## **BID ADDENDUM NO. 3**

### **Johnson Student Center**

### **Building Demolition, Increment 1 (Demolition) and Increment 2**

RANCHO SANTIAGO COMMUNITY COLLEGE DISTRICT  
SANTA ANA, CA

© HILL PARTNERSHIP INC. 2015  
SHEET TITLE  
**FIRST FLOOR PLAN - SOUTH**  
SHEET NUMBER

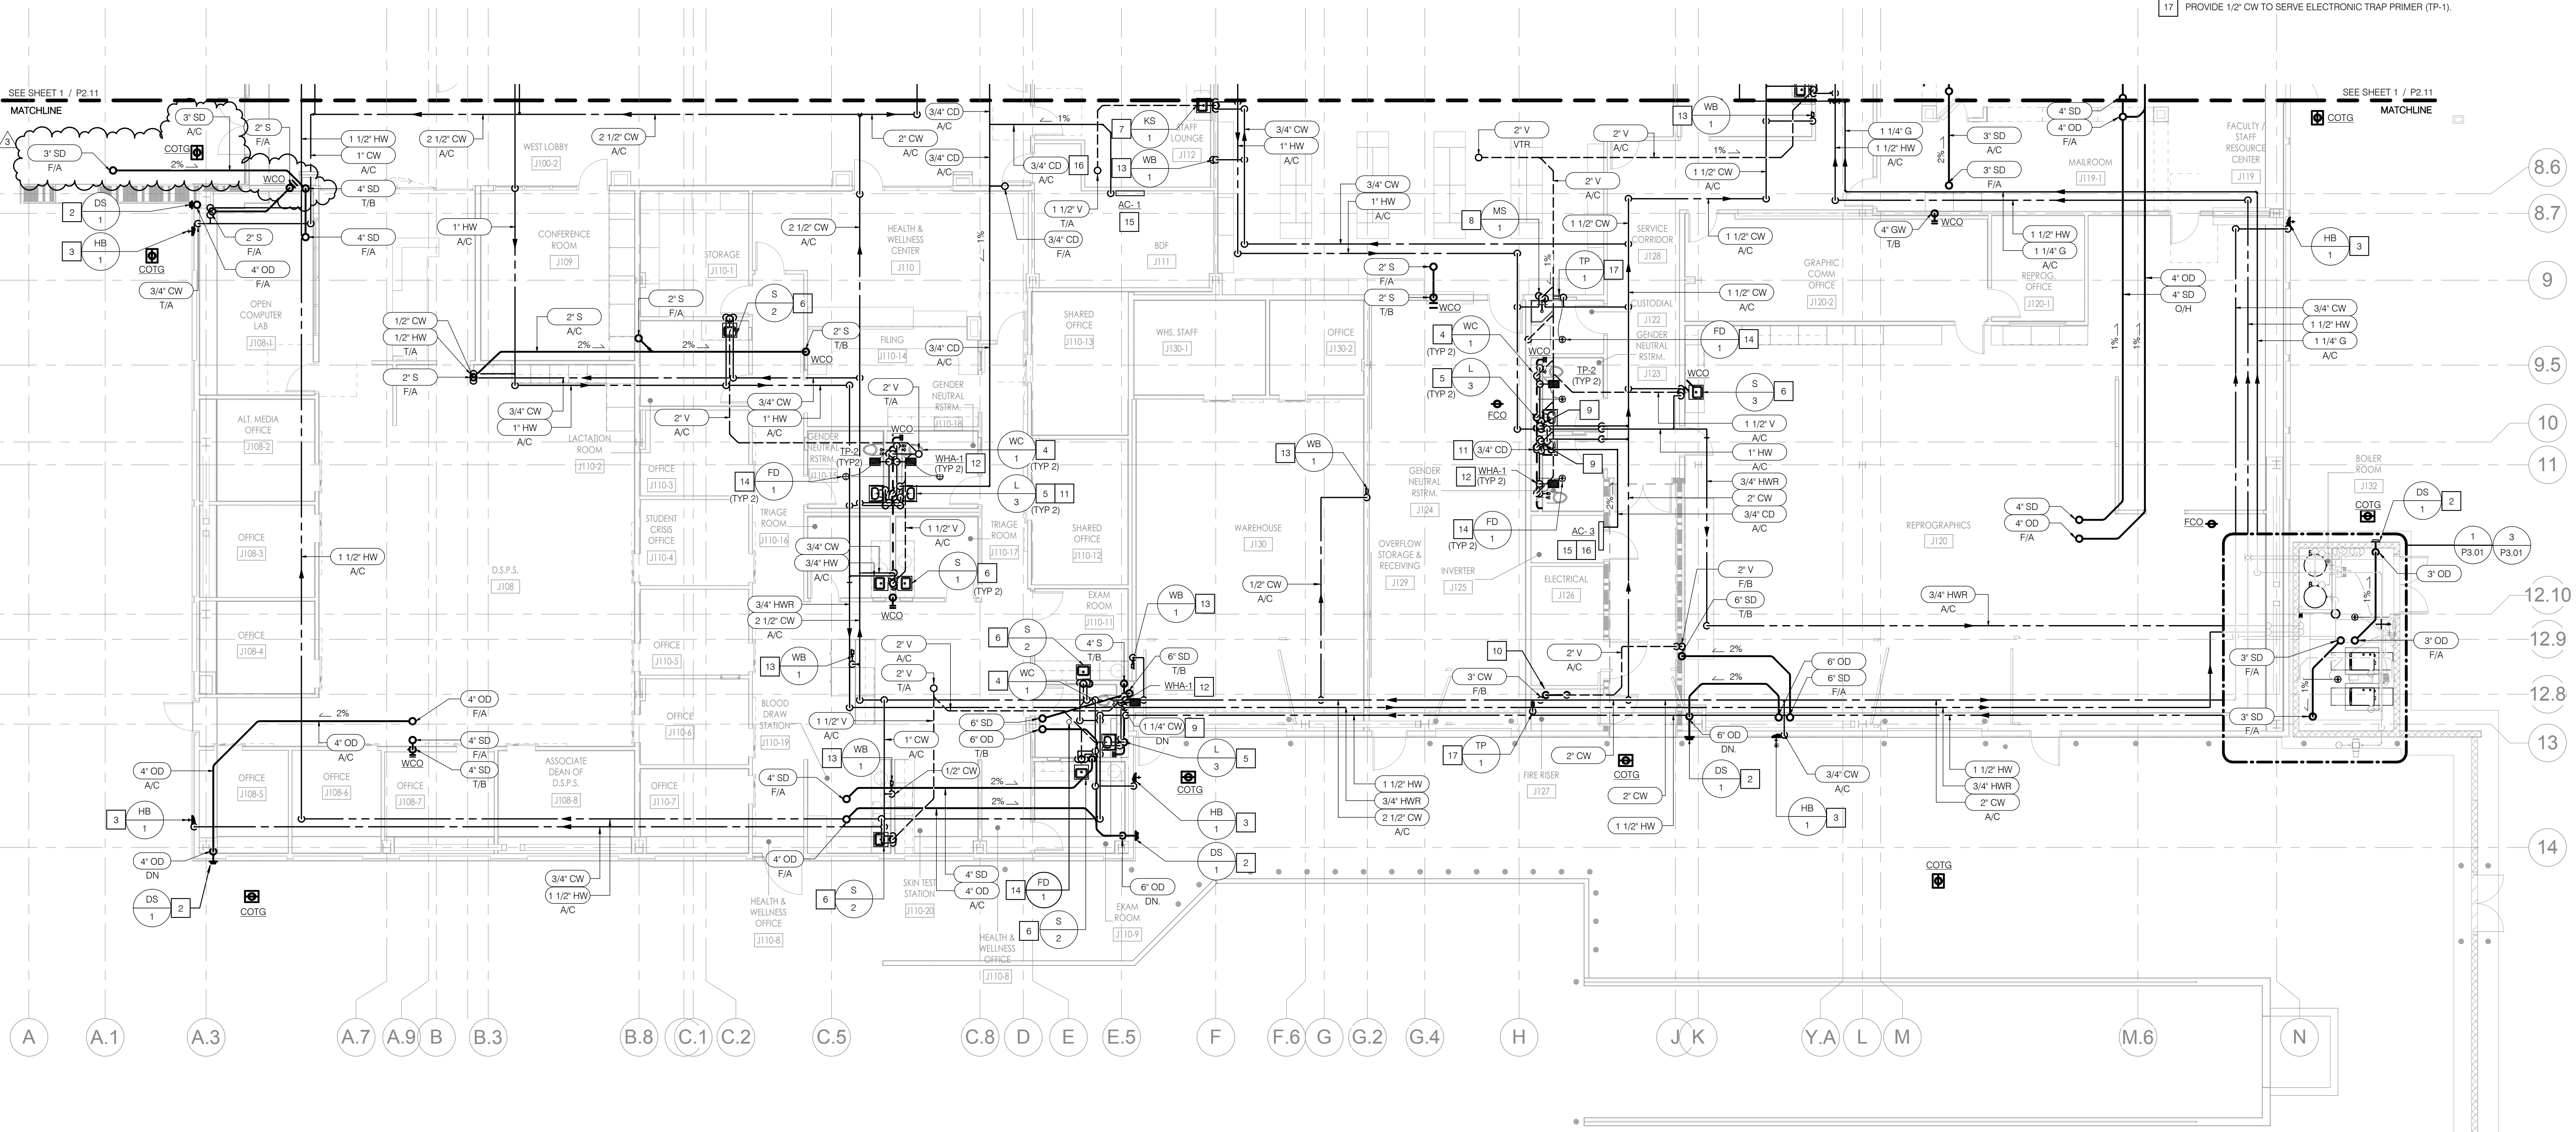
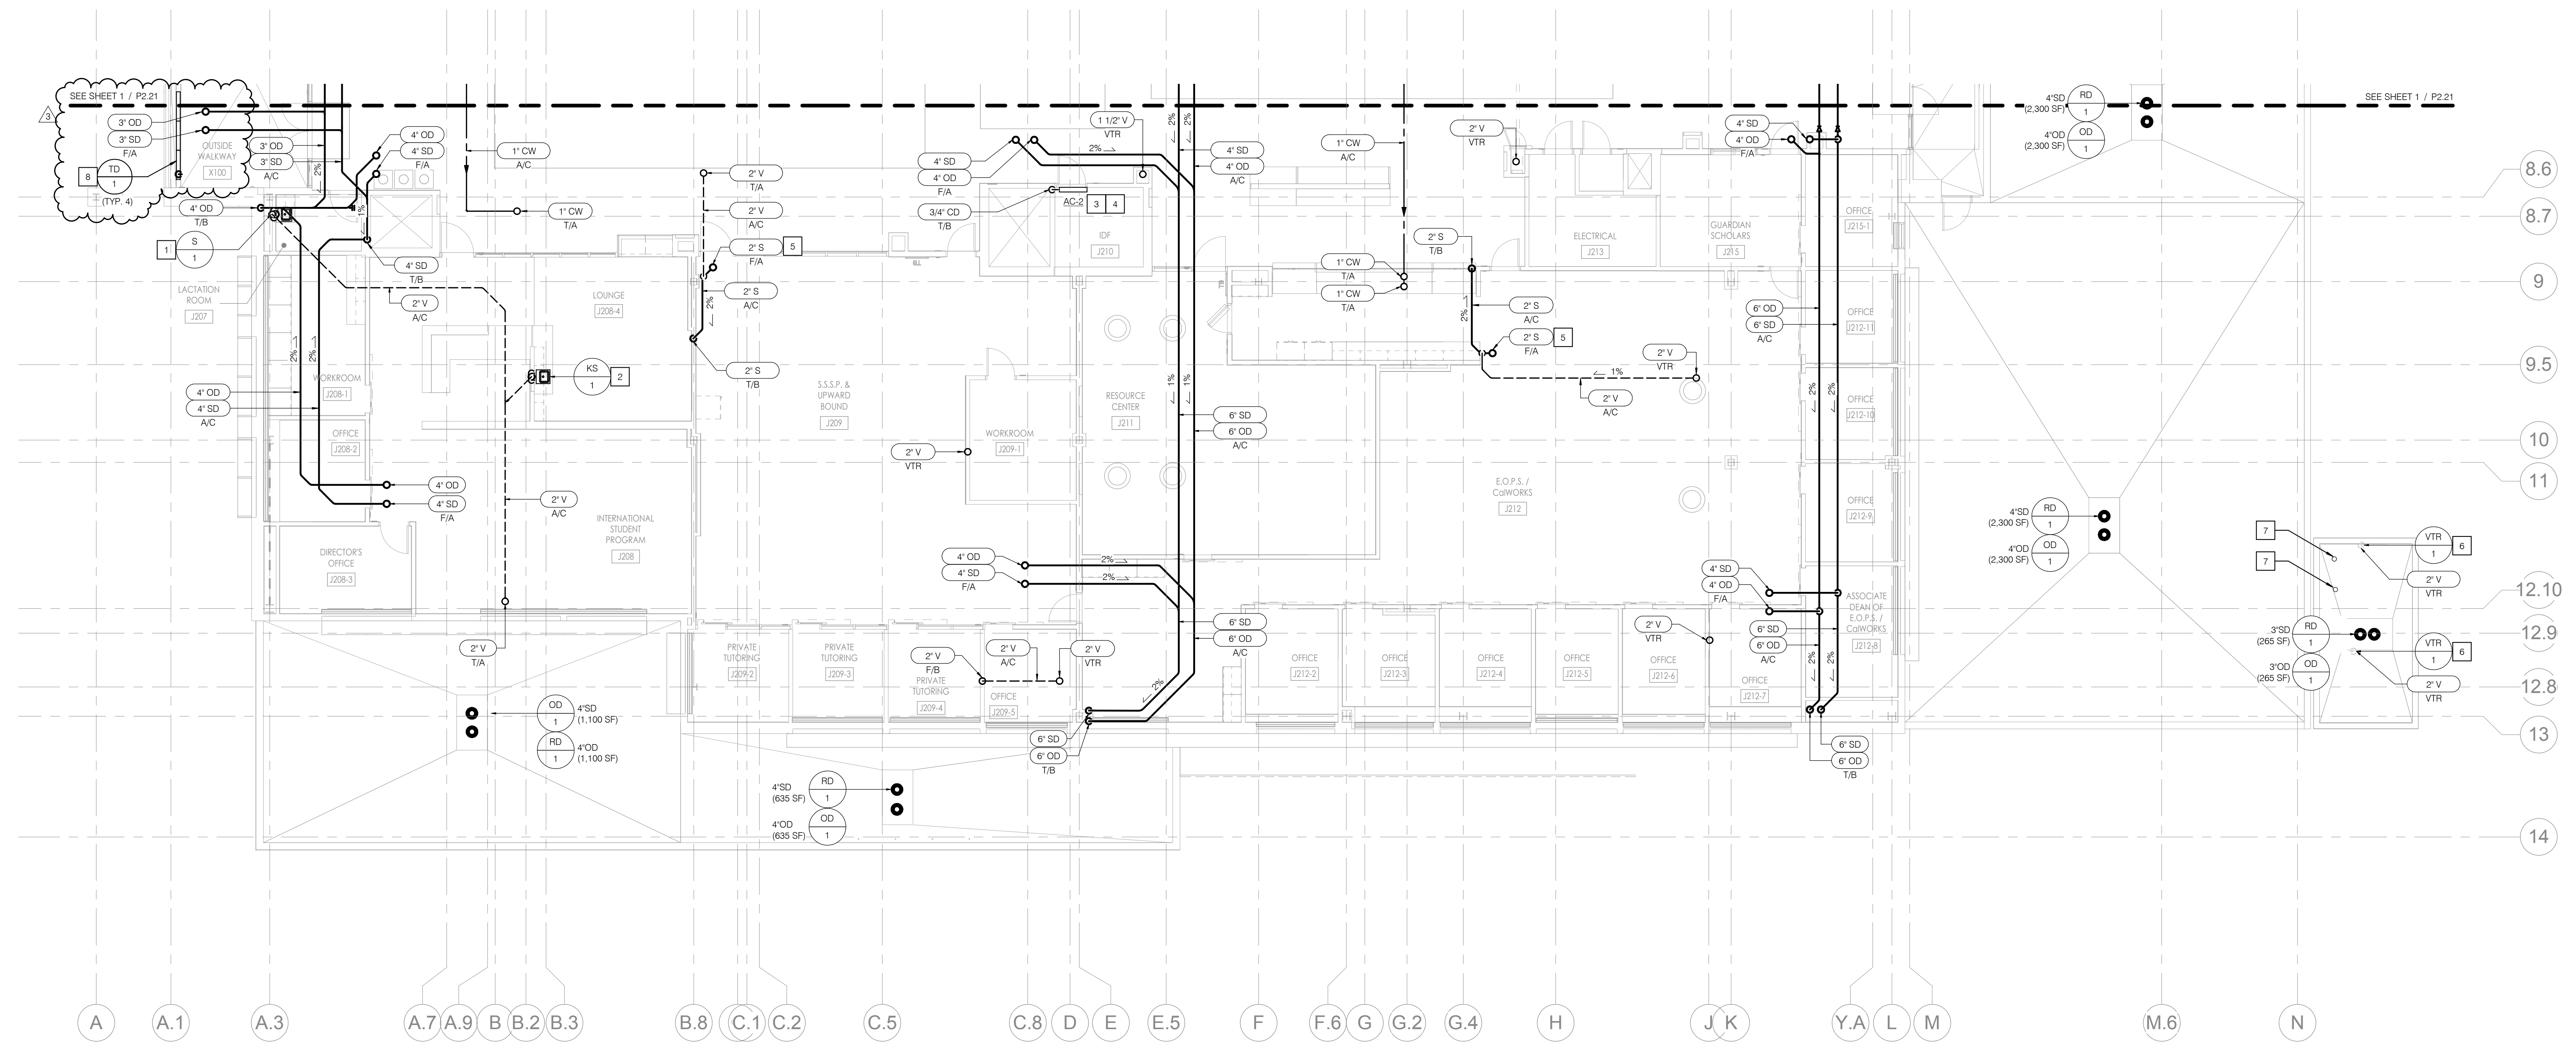
DATE:	09/13/2018		
FROM:	S.Monsen - McCarthy	EMAIL:	SMonsen@McCarthy.com
SPECIFICATION NUMBER:		DRAWING NUMBER:	A6.10, Detail 13 P2.21 & P2.22
REQUESTED CLARIFICATION:			
Reference drawing A6.10, Detail 13 – Architectural drawing indicates trench drain at second floor, Stair 1, Keynote 221319.A4. Plumbing drawings P2.21 & P2.22 do not indicate a trench drain at this location. Please clarify.			
RESPONSE TO CLARIFICATION, <b>SUBMITTED AS PART OF AN ADDENDUM:</b>			
Refer to attached revised Plumbing sheets P2.12 & P2.22 showing the added trench drains (TD-1) with associated piping as part of Addendum 3.			
RESPONSE PROVIDED BY:	Eric Gomez - P2S Inc.	DATE:	09/17/18

- PROVIDE TRENCH DRAIN CHANNELS AT EDGE OF BALCONY. COORDINATE EXACT LENGTH WITH ARCHITECTURAL DRAWING 13/A6.10. REFER TO P2.12 FOR DRAIN OUTLET LOCATIONS FROM DRAIN CHANNELS.
